**TOWN OF TUNNELTON MUNICIPAL SEWER WORKS
PRESTON COUNTY, WEST VIRGINIA**

**PHASE II – 0.04 MGD WASTEWATER TREATMENT PLANT AND COLLECTION
SYSTEM UPGRADES**

ADDENDUM #1

AUGUST 24th, 2022

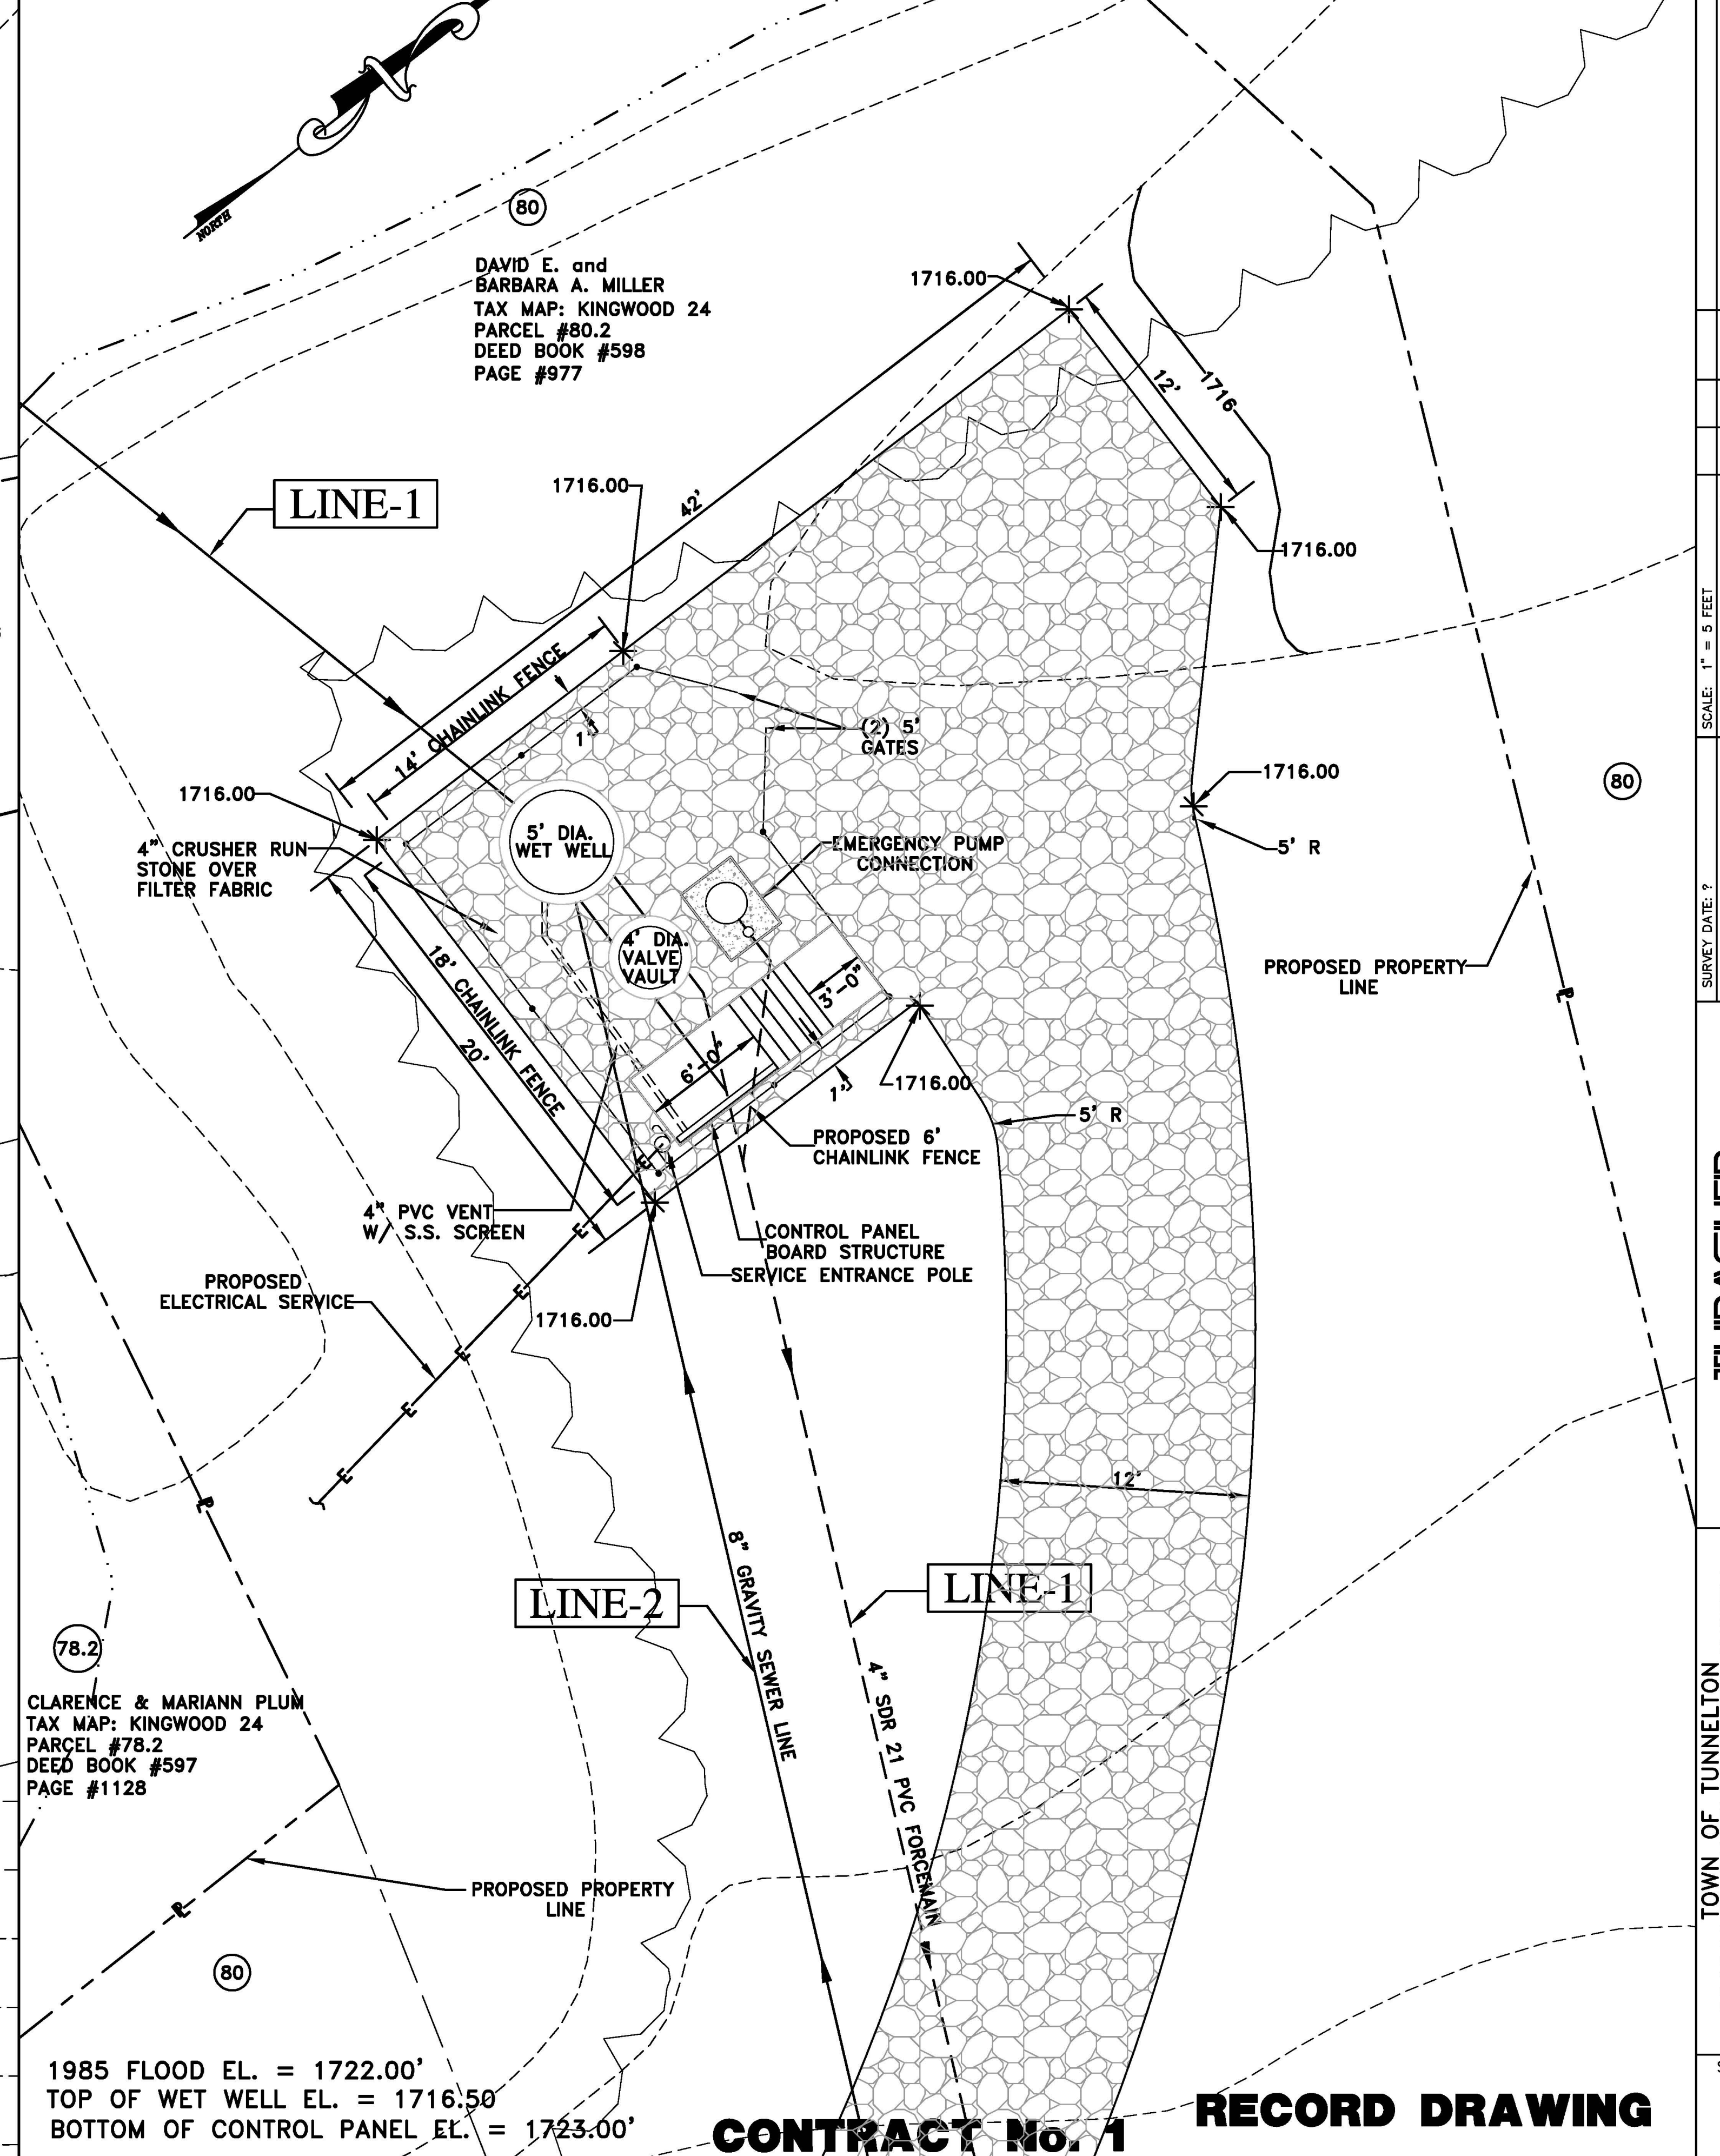
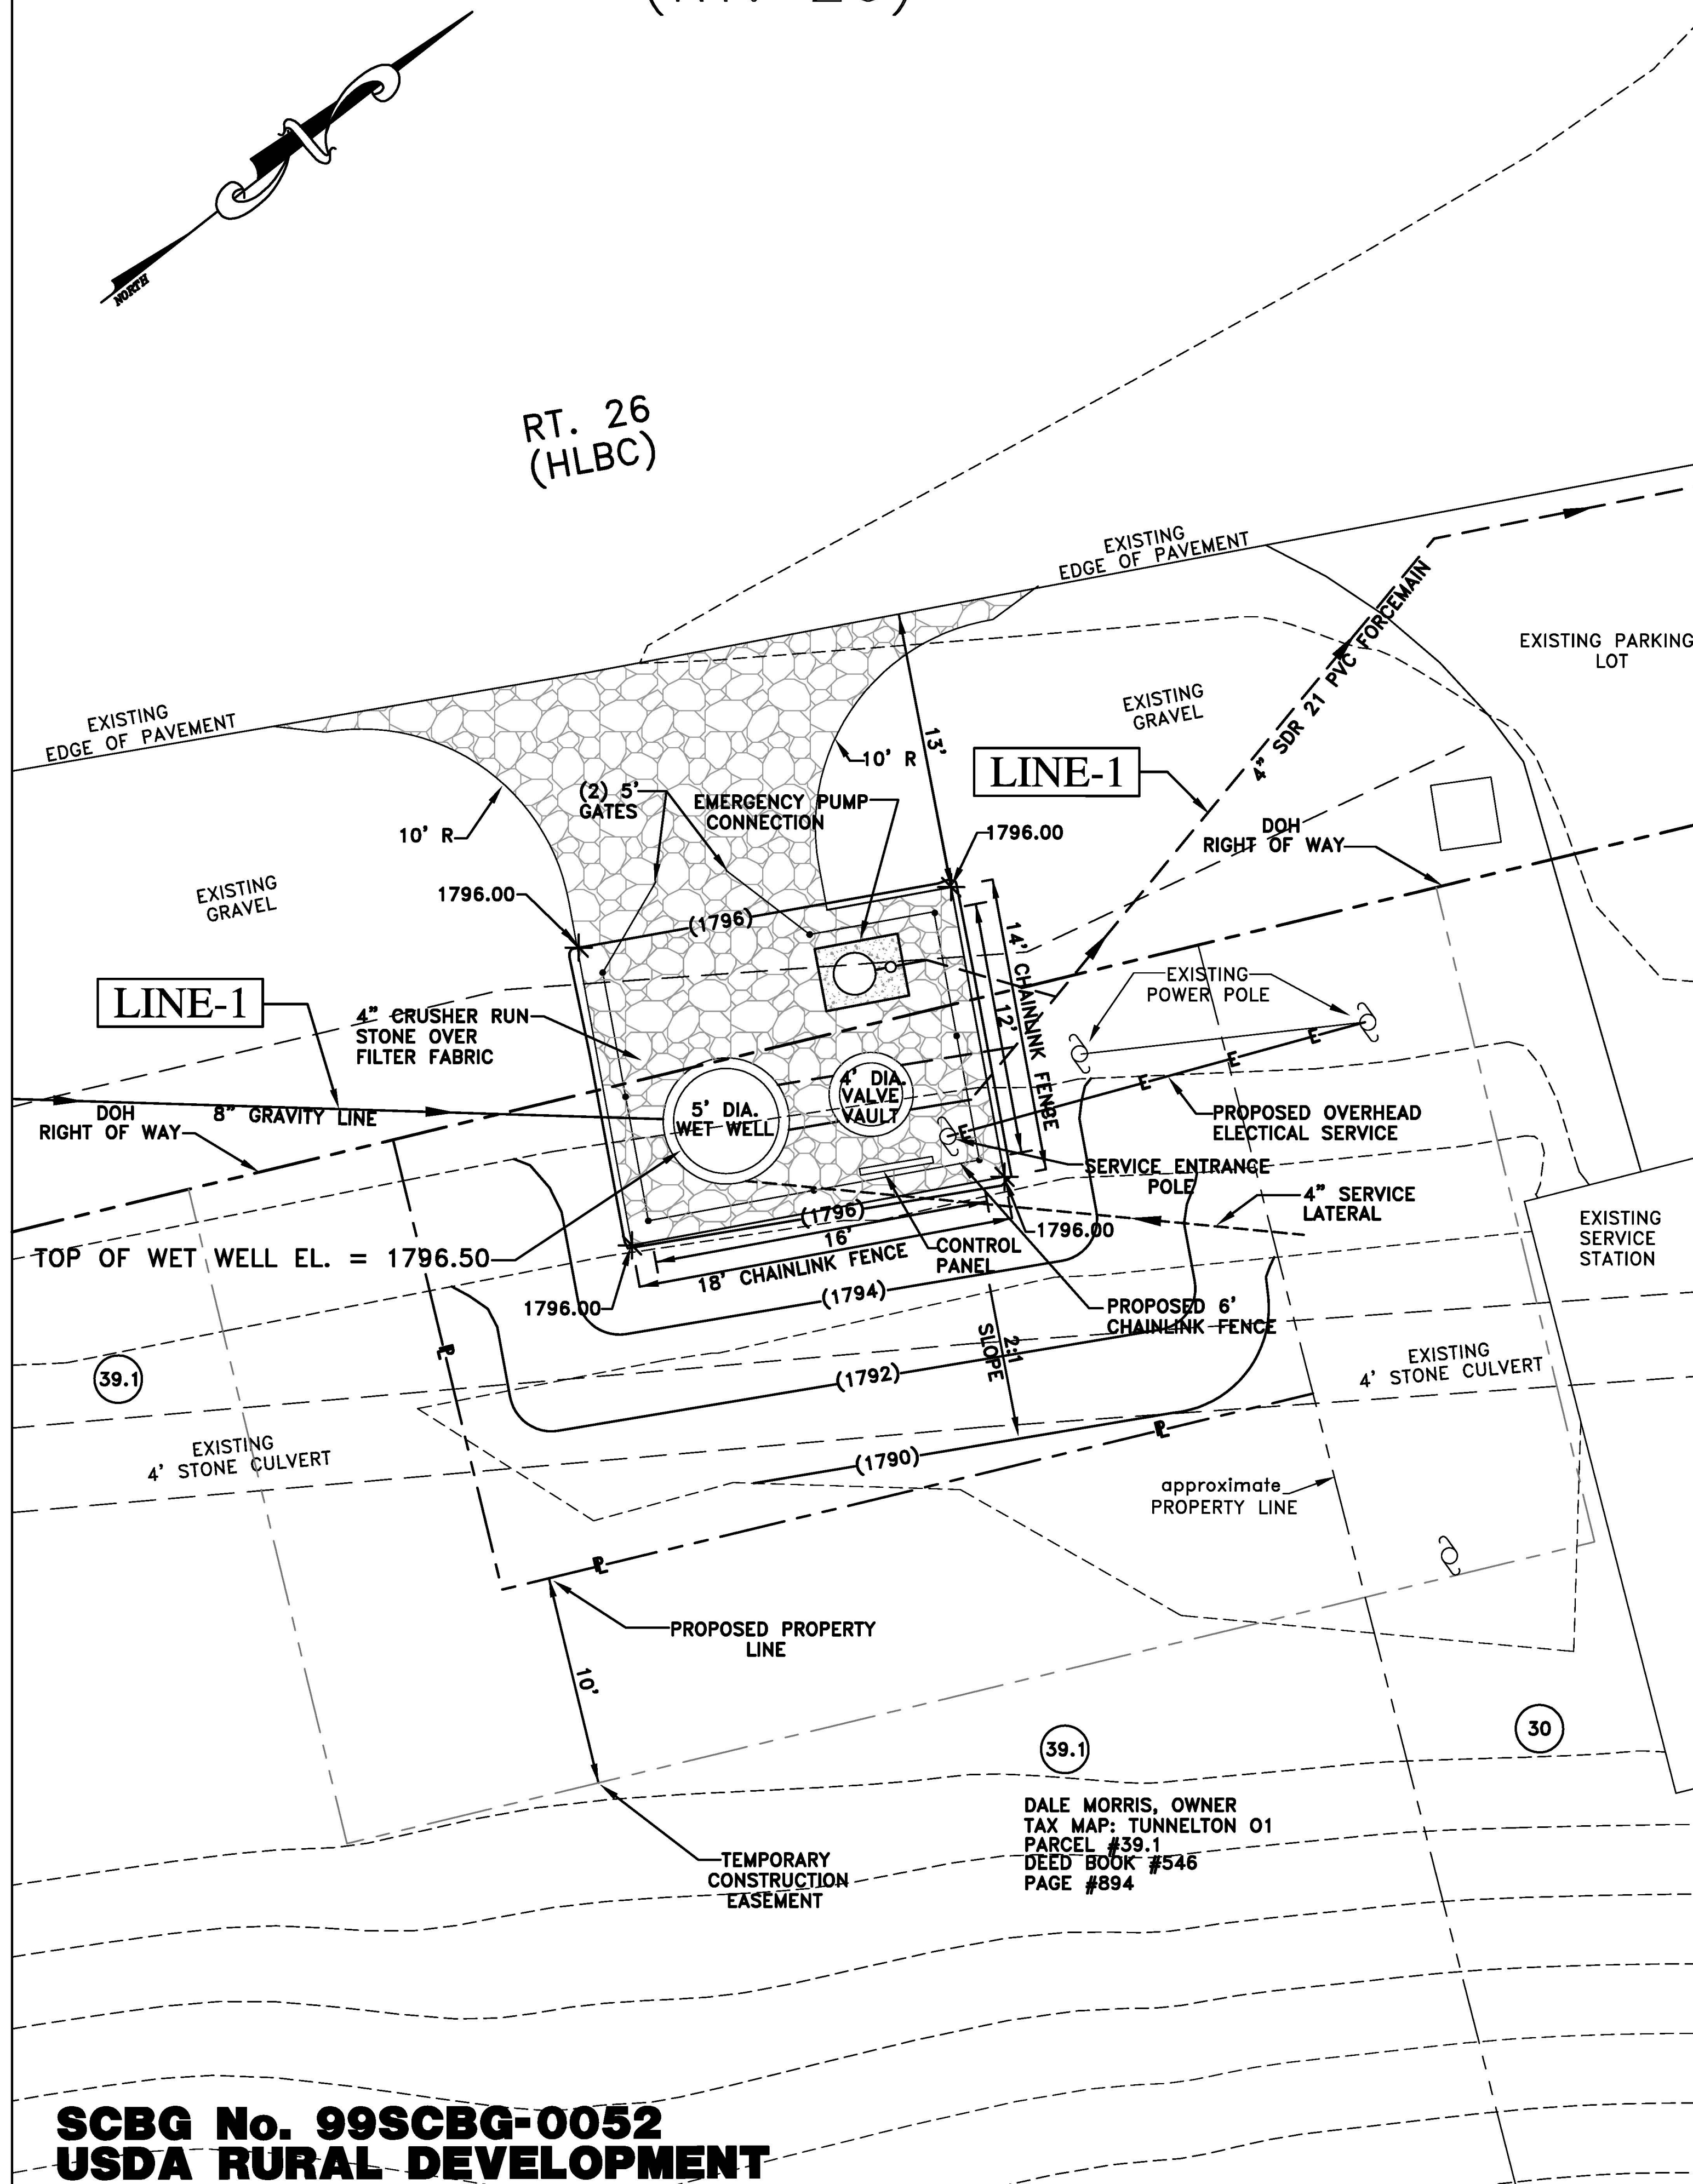
4. How are we to bypass pump during work at Pump Station #2?

The Engineer does not determine means and methods. Record Drawing Sheet Nos. 16 and 21 have been provided as part of this Addendum for reference to the location of existing manholes upstream of the station and alignment of the force main.
